**VILLAGE OF POMONA  
PLANNING BOARD MEETING**

The Chabad of the Heights project was last reviewed by the Planning Board at the May 14, 2026 meeting. The site plans have been revised in accordance with the previous review comments. Responses to the review letters and comments are provided in **bold** below.

PROJECT:  
**CHABAD OF THE HEIGHTS**  
34 NORTH RIDGE ROAD

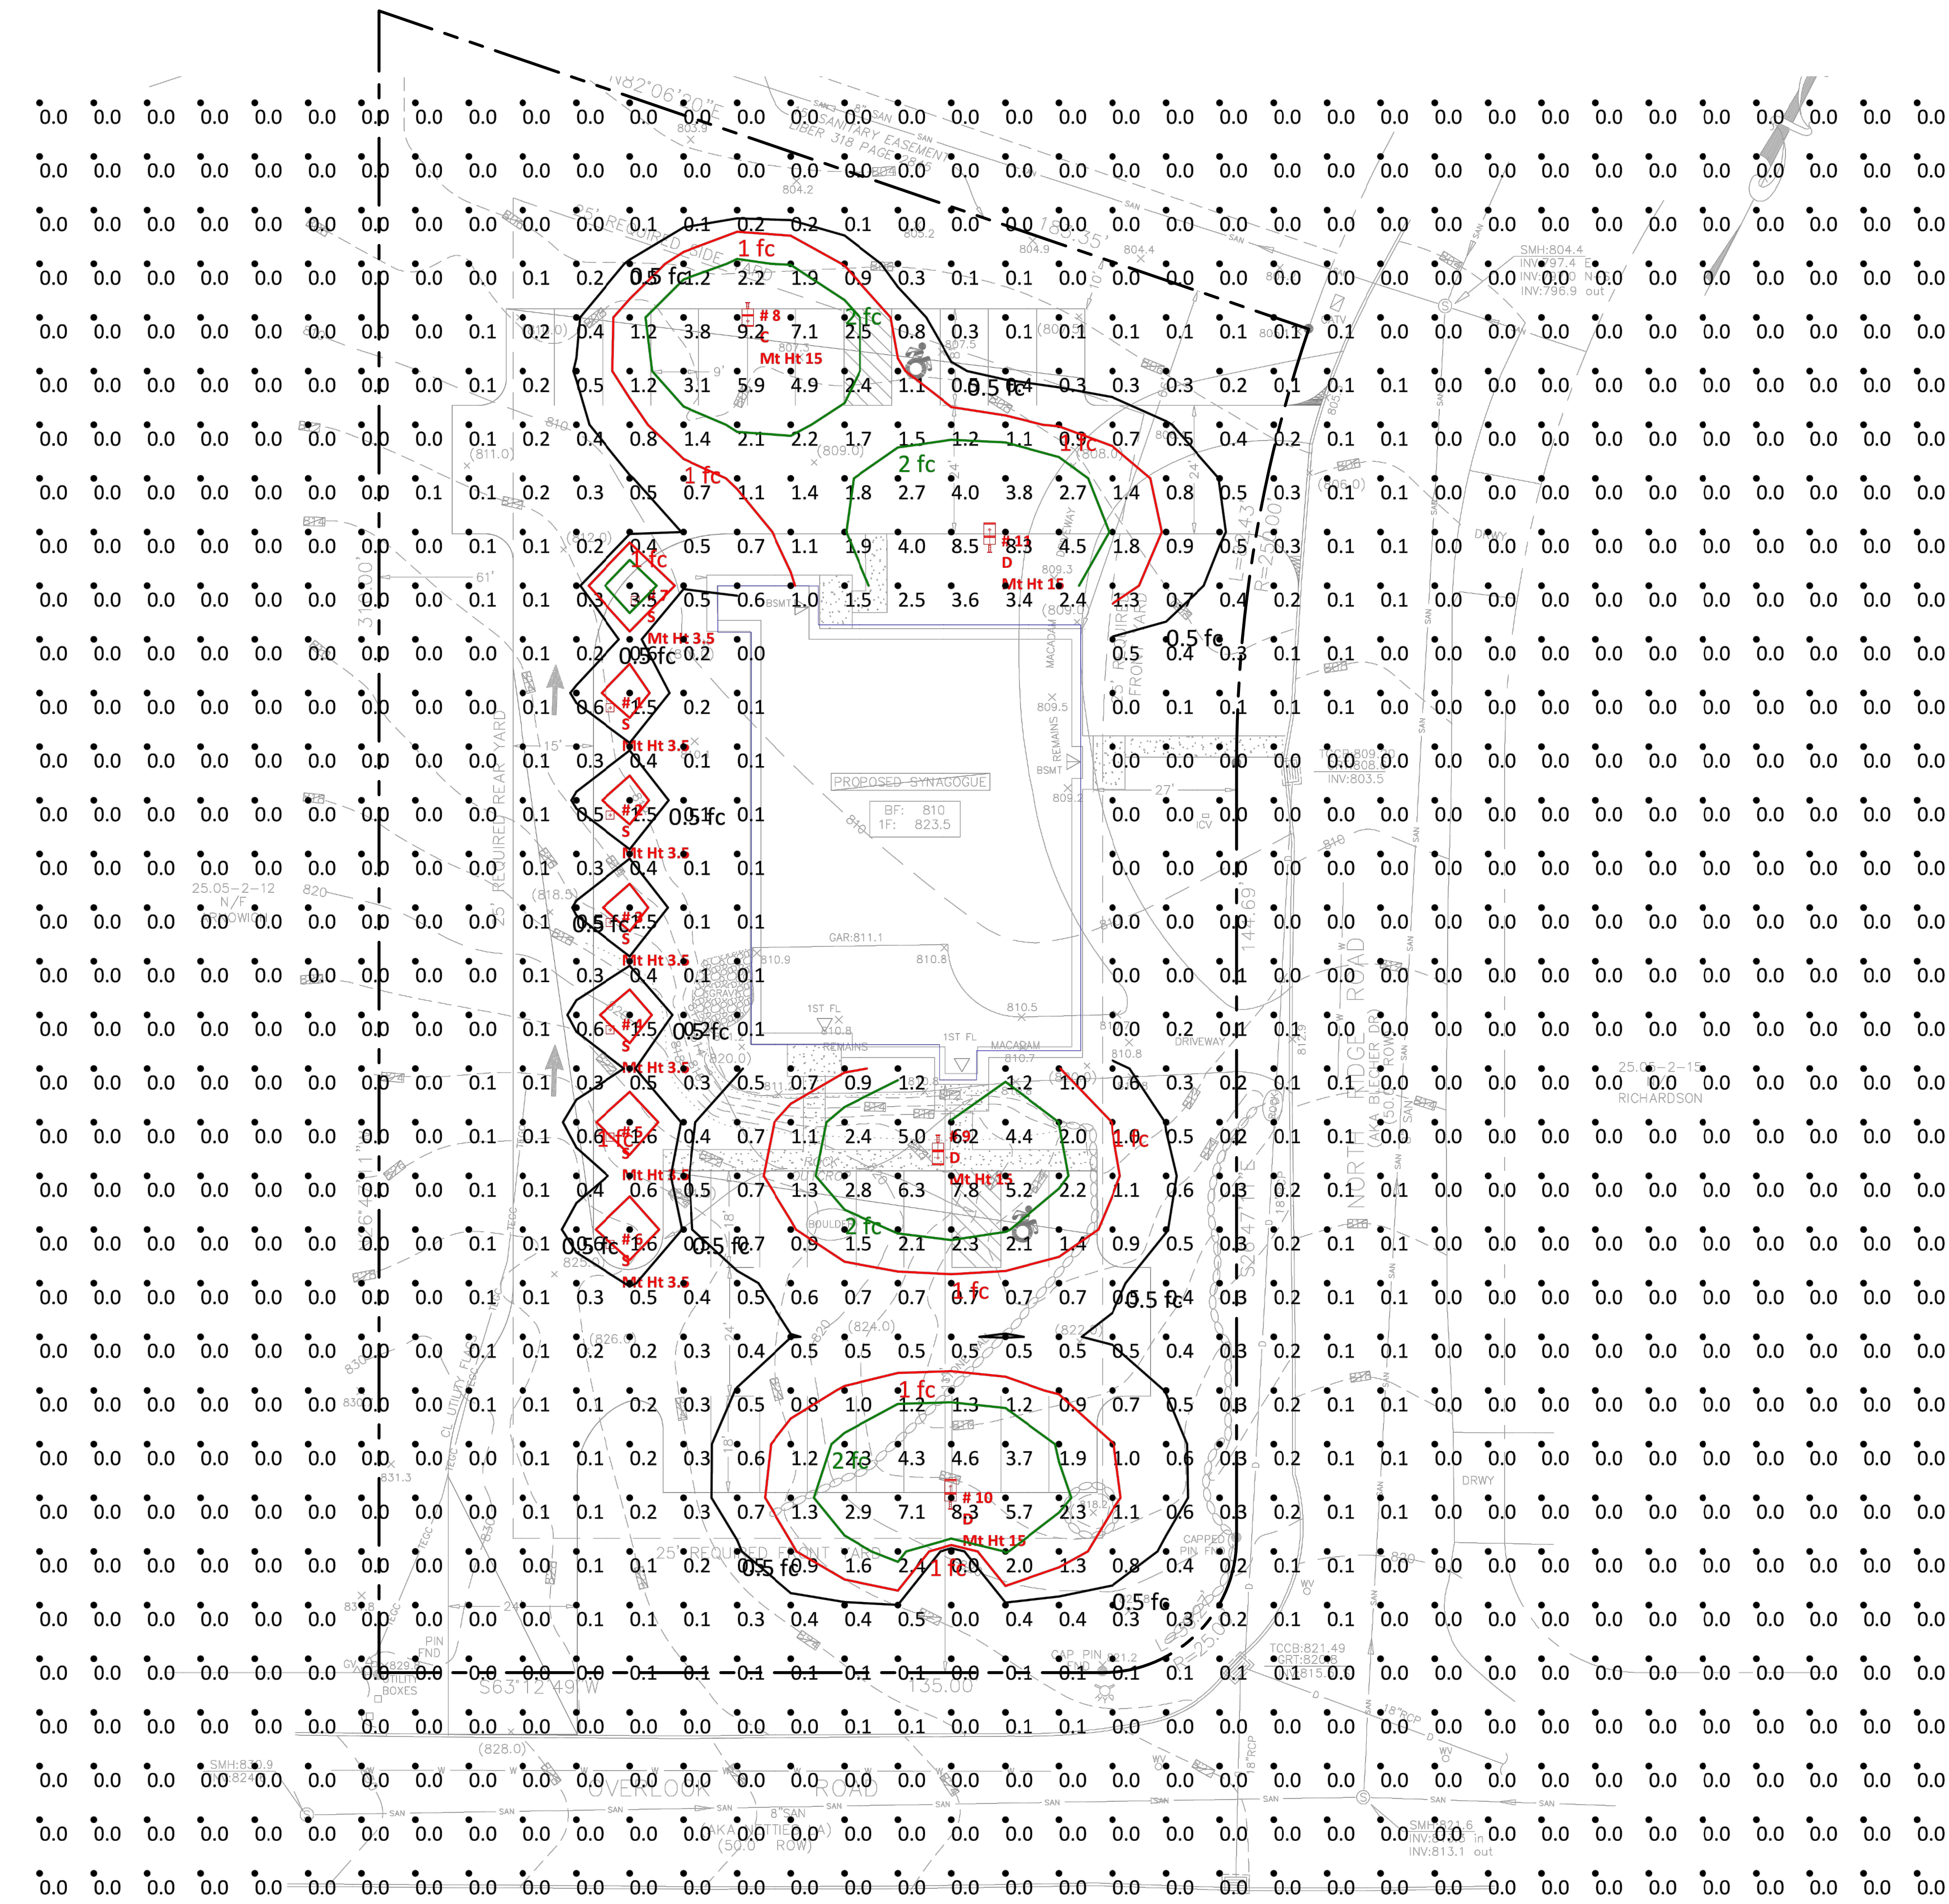
8. 4/2026 – The average, max and min footcandles calculated on sheet 3 of the lighting plan seems to be for the entire lot as opposed to just the hardscape areas that are intended to be lit. The average and minimum lighting levels of just the parking areas and sidewalks should be provided. The plan proposes minimum illumination of most hardscape areas at 2.0 footcandles with only edges and corners at 1.0 footcandle or slightly less. This is excessive. With total hardscape area to be lit of just 12,000 square feet, total lumens of the proposed fixtures should not exceed 30,000 lumens (2.5 lumens per square feet) and ideally would be closer to 20,000 lumens, given the low-density single-family nature of the neighborhood. The applicant is proposing approximately 70,000 total lumens, more than twice the typical standard for a suburban multifamily neighborhood and more consistent with an industrial area. We recommend the applicant consider eliminating three of the seven fixtures and consider installing different optics to more efficiently light the area. We recommend that color temperature be limited to 3000k to be more compatible with the residential area. Excessive blue light can impact neighbor's sleep and cast excessive glare on wet surfaces.

**5/2026** – Comment remains.

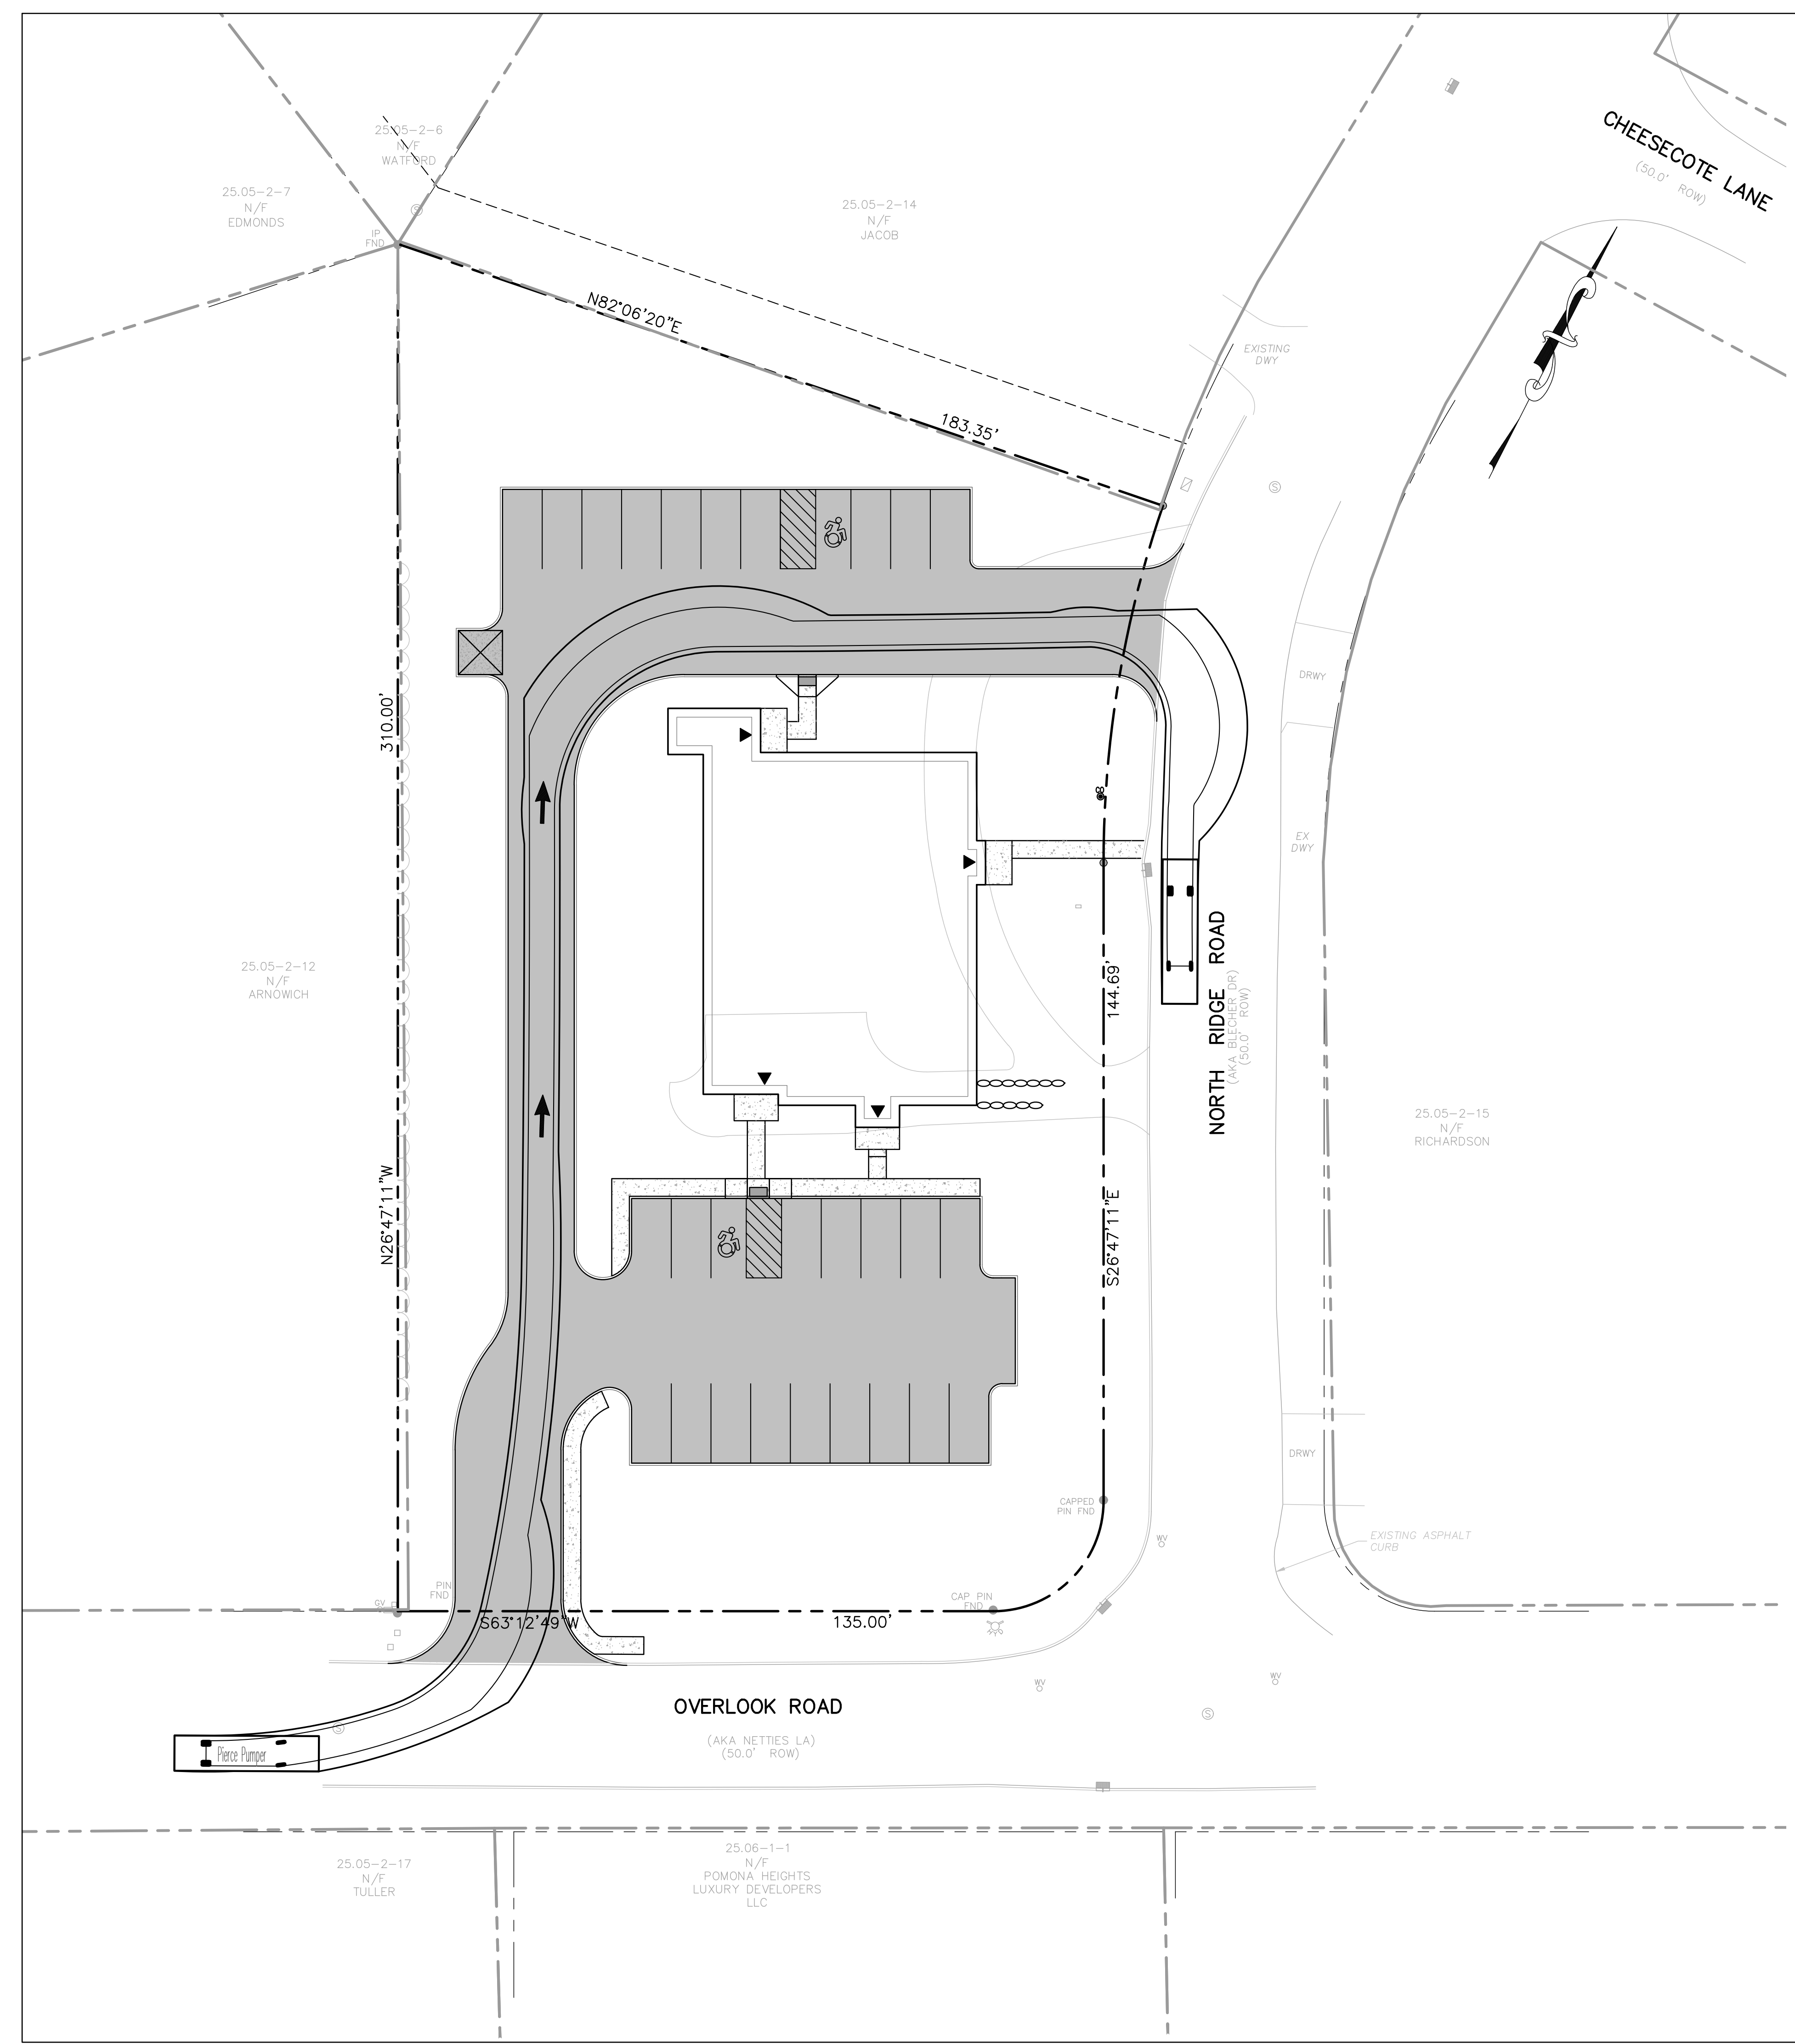
S-20. Provide fire truck turning templates, entering the site from both streets. **A Fire Truck Maneuvers Plan has been added.**
